# Access Compliance Report

## Public Rights-of-Way

### (Curb Ramps)

Intersection ID: 54779	Main Street: SHARON AMITY RD	Cross Street: CHARLESTON DR	Location: E
ADA ID: B4371EA4C76A	Ramp Type: Perp	Initial Pass/Fail: Fail	Overall Compliance: No
Codes/Mitigation Info/Possible Solution		Field Measurements/Component Compliance	
Severity Score: 13.75

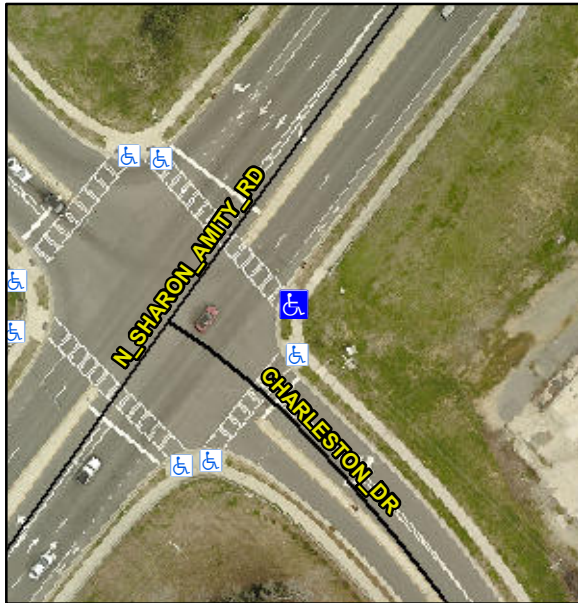
**R304.2.2**

Compliance	Description	Data	Compliance	Description	Data
N/A	Ramp Length (in)	65.0	No	Ramp Slope (%)	8.9
Yes	Ramp Width (in)	59.0	Yes	Ramp XSlope (%)	2.6
N/A	Flare Type LT	N/A	N/A	Flare Type RT	N/A
N/A	Flare Slope LT (%)	N/A	N/A	Flare Slope RT (%)	N/A
N/A	Flare Traversable LT?	N/A	N/A	Flare Traversable RT?	N/A
N/A	Landing Length (in)	N/A	N/A	DWS Provided?	N/A
N/A	Landing Width (in)	N/A	N/A	DWS Contrast?	N/A
N/A	Landing Slope (%)	N/A	N/A	DWS Length (in)	N/A
N/A	Landing X Slope (%)	N/A	N/A	DWS Full Width?	N/A
N/A	Landing Curb? (Y/N)	N/A	N/A	DWS Offset (in)	N/A
N/A	Shared Landing?	N/A			
N/A	Gutter Ponding?	N/A	N/A	Gutter Slope (%)	N/A
N/A	Gutter Lip Ht (in)	N/A	N/A	Gutter X Slope (%)	N/A
N/A	Painted X Walk1?	Yes	N/A	Painted X Walk2?	N/A
	X Walk 1 Direction	To NW		X Walk 2 Direction	N/A
N/A	X Walk 1 Width (in)	112.0	N/A	X Walk 2 Width (in)	N/A
	X Walk 1 Slope (%)	2.7		X Walk 2 Slope (%)	N/A
	X Walk 1 X Slope (%)	5.5		X Walk 2 X Slope (%)	N/A

**Remove & Replace Entire Ramp.**
